Response to comment #246

Comment #246 from Eric Maniloff

No extender STAT – Remote Degrade signaling

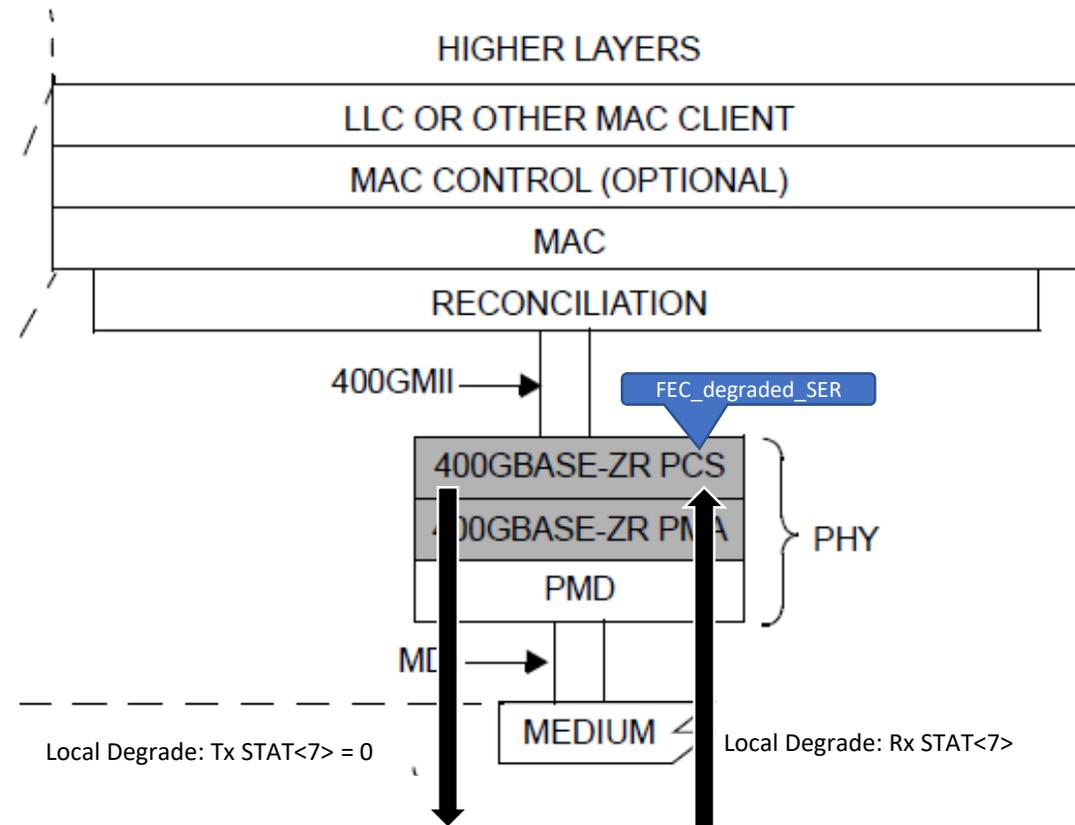
Note: Stat<6> = remote degrade

Extender STAT - Remote Degrade signaling

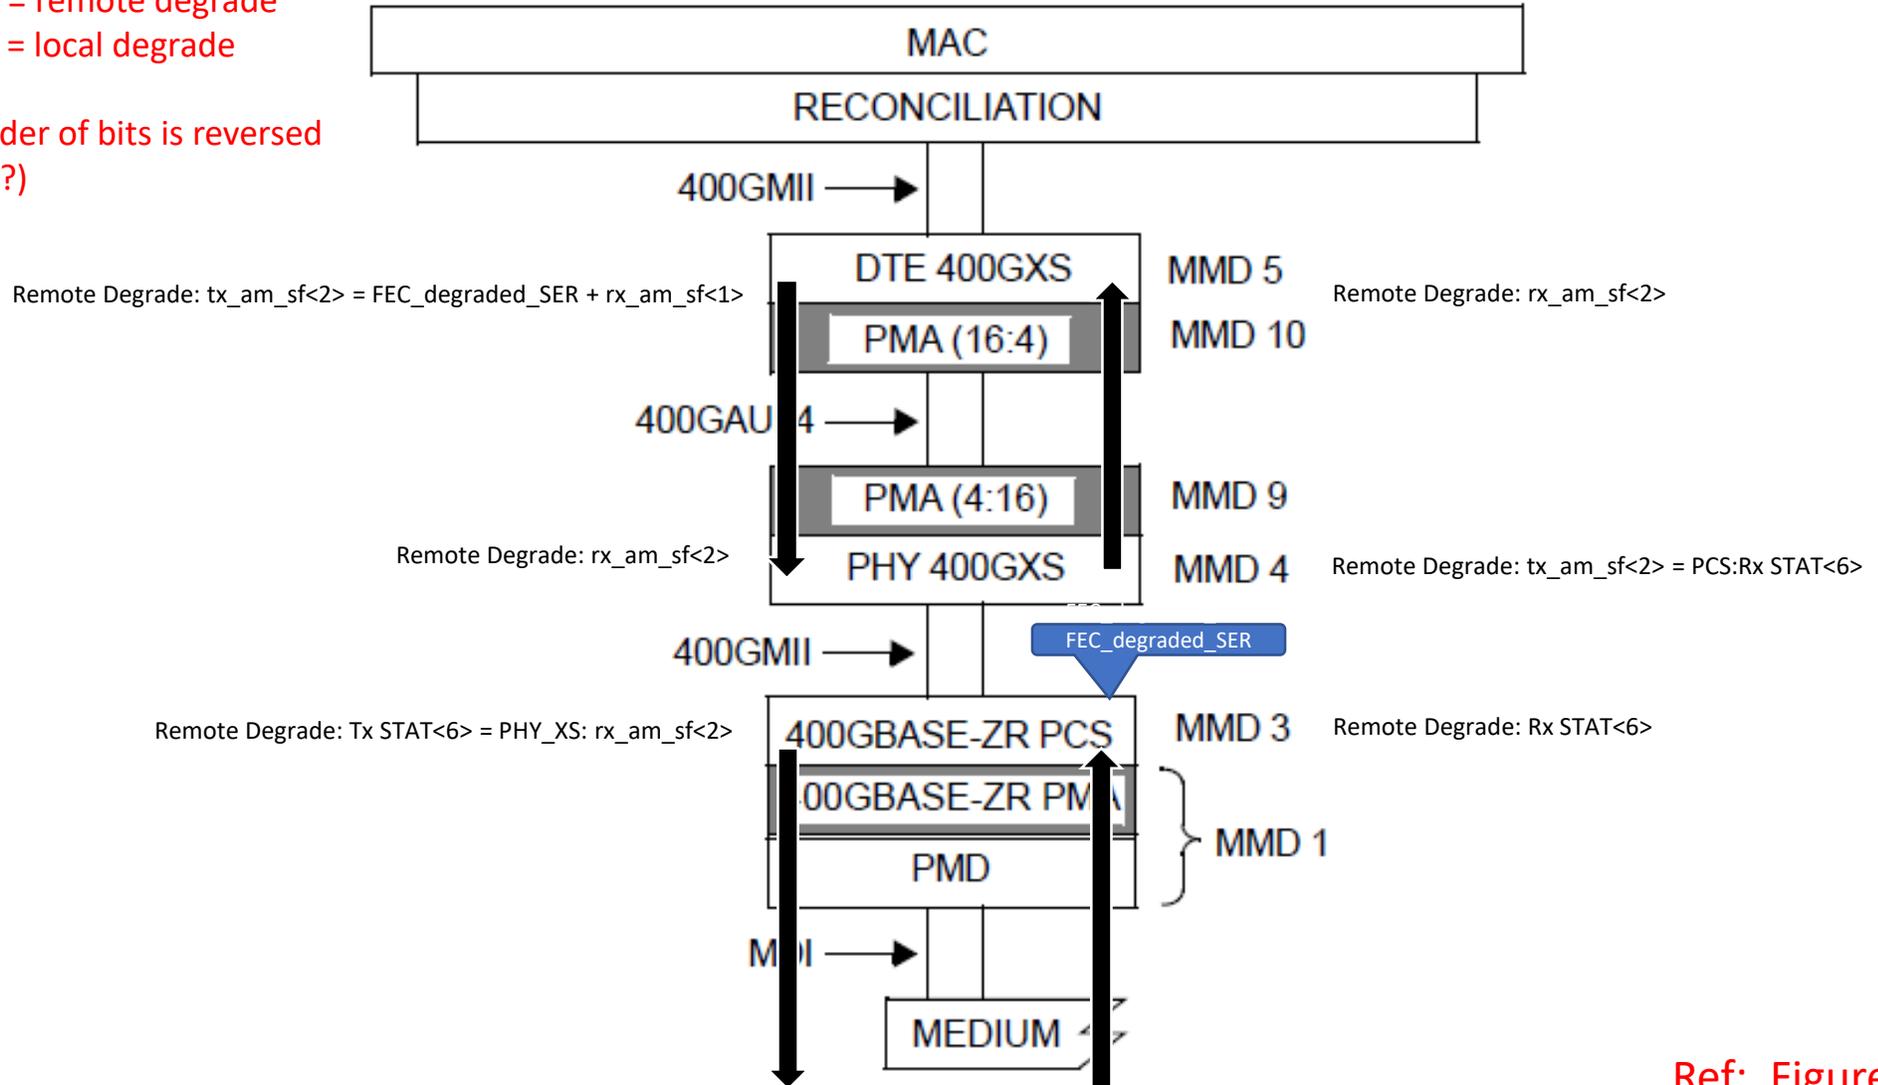
(note, interesting that order of bits is reversed
 Between stat and am_sf ?)

Extender STAT - Local Degrade signaling

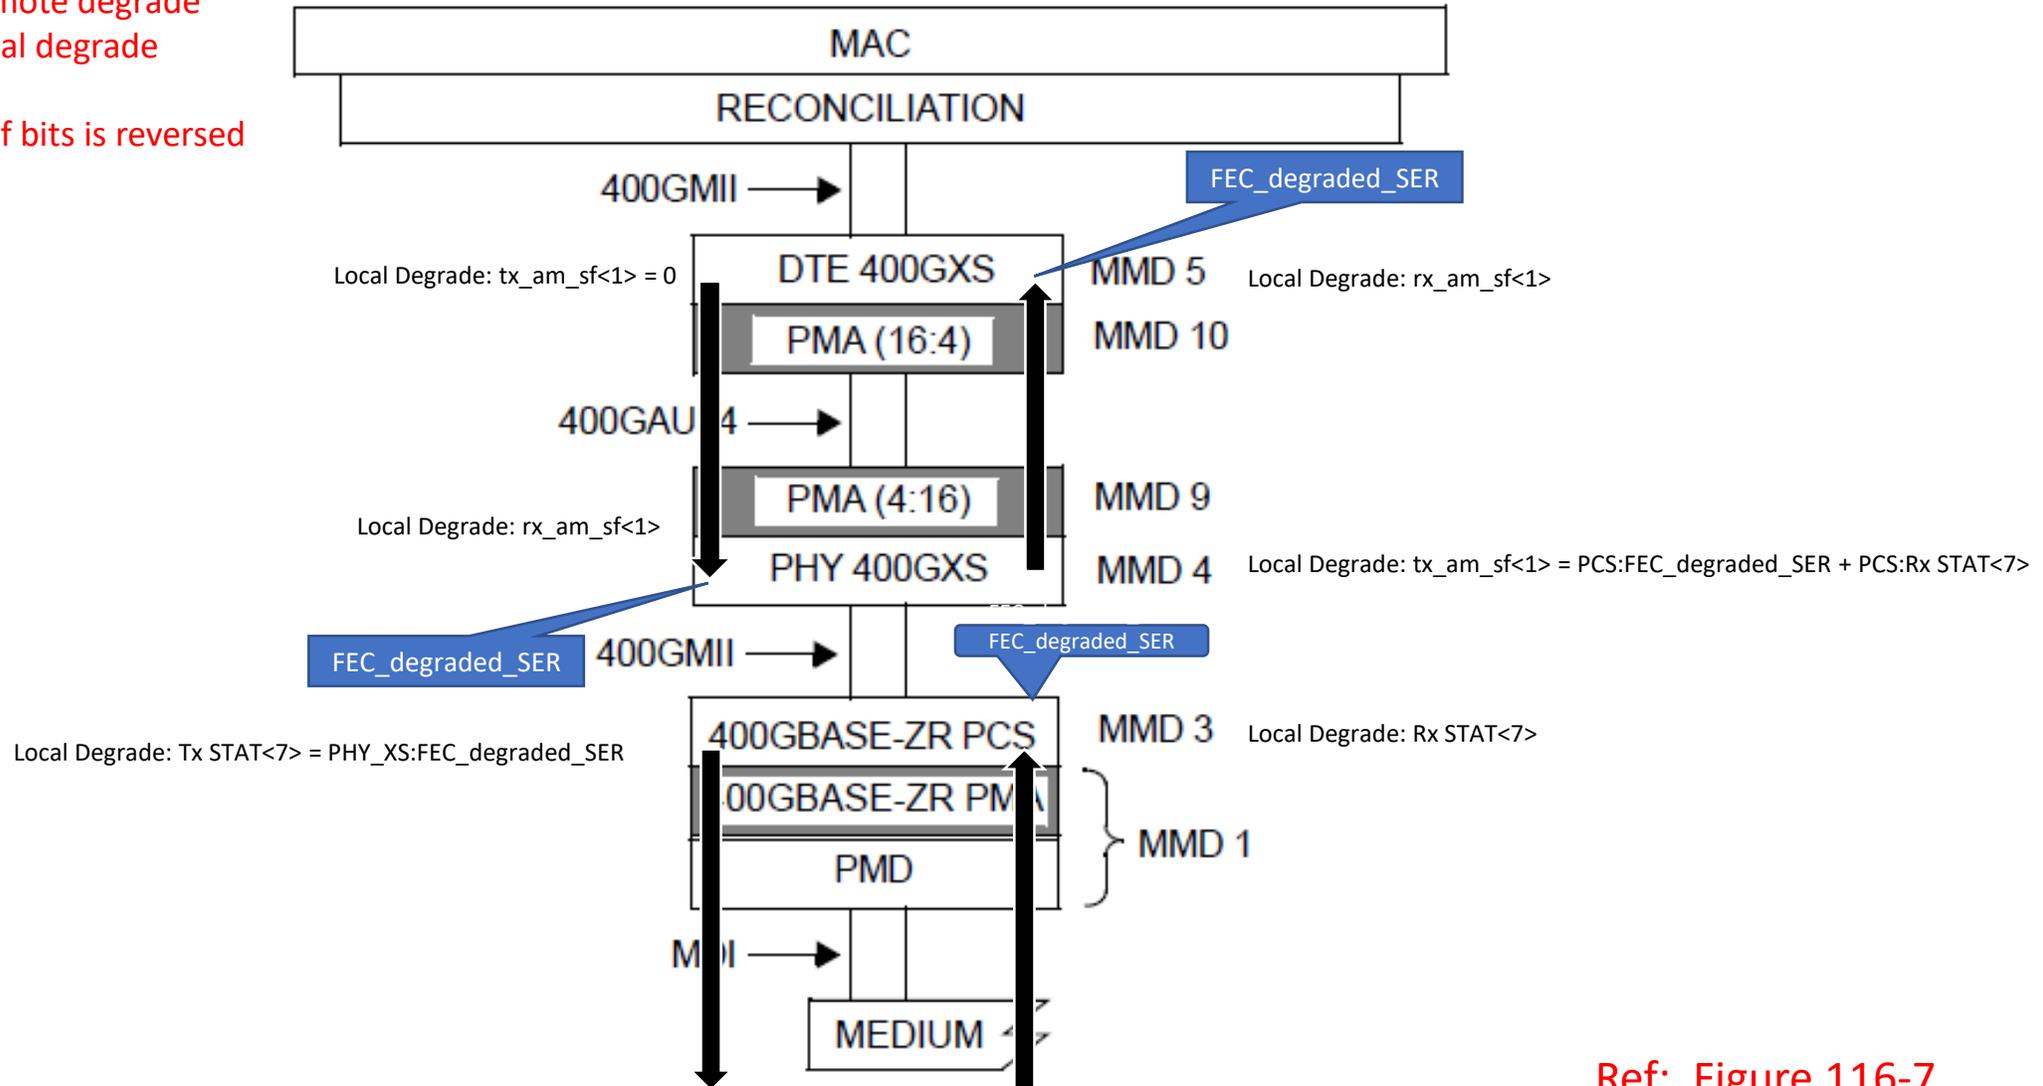
(note, interesting that order of bits is reversed
 Between stat and am_sf ?)
